Service Info

New tensioner pulley 531 0859 10

Complete coverage for D5204 and D5244 engines

Image 1: 531 0859 10 — new tensioner pulley

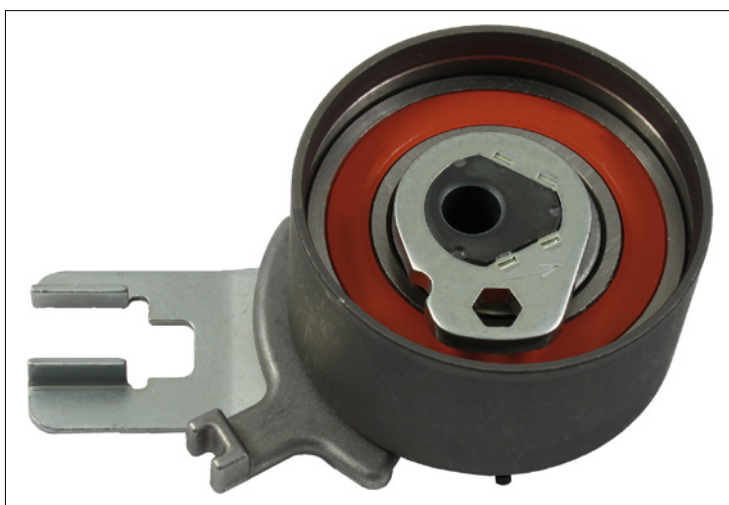
In the specified vehicles, tensioner pulley 531 0515 10 (figure 2) can only be used for a limited range of engine numbers.

For this reason, Schaeffler Automotive Aftermarket has developed the new tensioner pulley 531 0859 10 (figure 1). This component covers all D5204 and D5244 engines over the entire construction period.

In terms of appearance, the two tensioner pulleys differ only in the design of the timing pointer.

Kit 530 0504 10 with tensioner pulley 531 0515 10 is replaced by kit 530 0582 10 with the new tensioner pulley.
